# HURRICANE CITY UTAH

### Hurricane Planning Commission Meeting Agenda

March 10, 2022

SLOPE MAP FOR:  
**HIDEAWAY RIDGE PHASE 2**

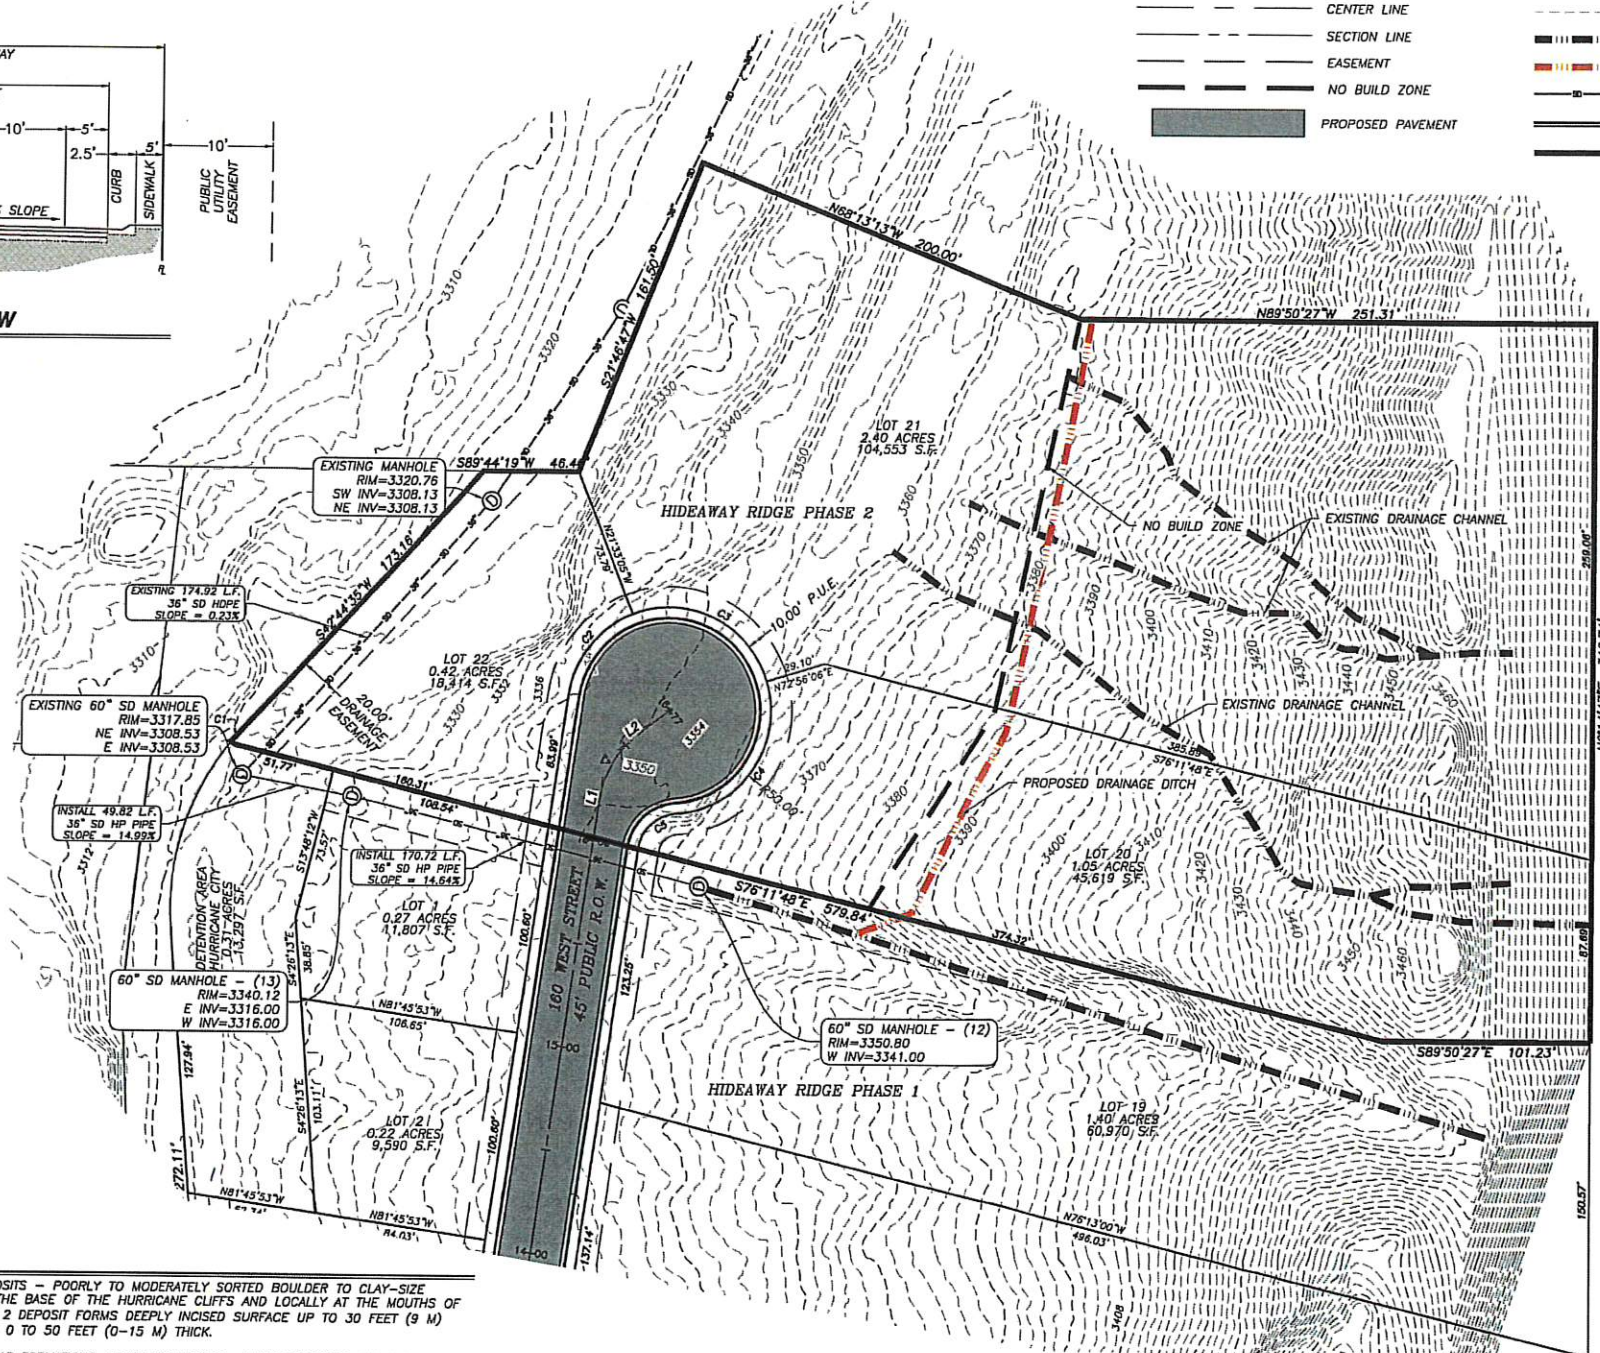
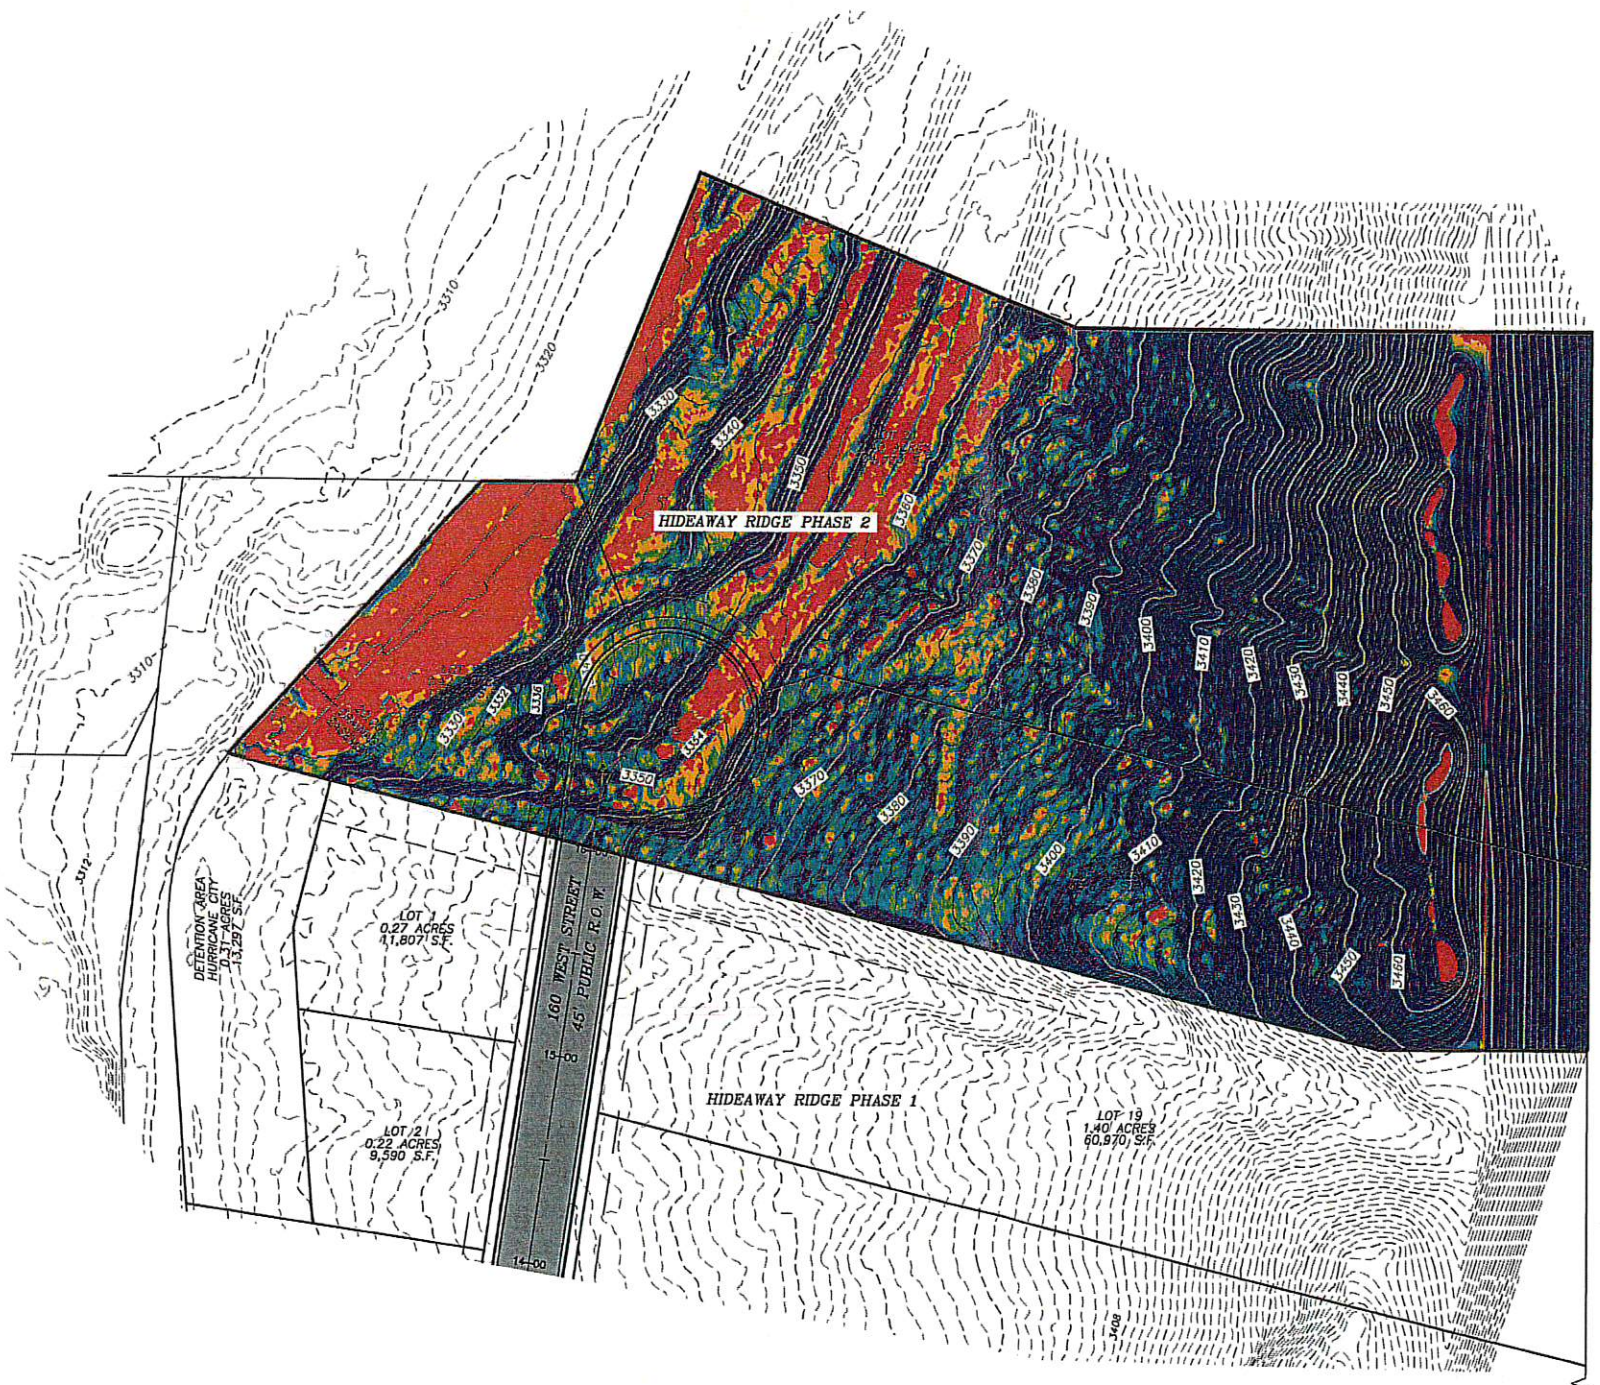
1. **Power:** Power is planned out for the area.
2. **Sewer:** Will be there with the other phases
3. **Streets:** No comments
4. **Water:** No problem
5. **Engineering:** Make sure cul-de-sac and water lines meet city standards on length. There is a fault line and geohazards that need to be noted on the plat. Need drainage plan.
6. **Fire:** Check the length of the cul-de-sac
7. **Cable/Phone/Gas:** No concerns.
8. **Water Conservancy:** No concerns.

3. The mapping is difficult to read for lot 21. That whole lower section should show an average slope area for the buildable area. It appears that it is in the high twenties, with large sections over 30%. Hurricane City code states that areas of 30% or more are unbuildable, with the exception of small out-cropping. Staff would like to see the building area average slope for each lot.

**Recommendation:** Staff recommends the Planning Commission review this application based on standards with Hurricane City Code. Staff recommends continuing this item until the cul-de-sac length and the issues of the sensitive land are resolved.
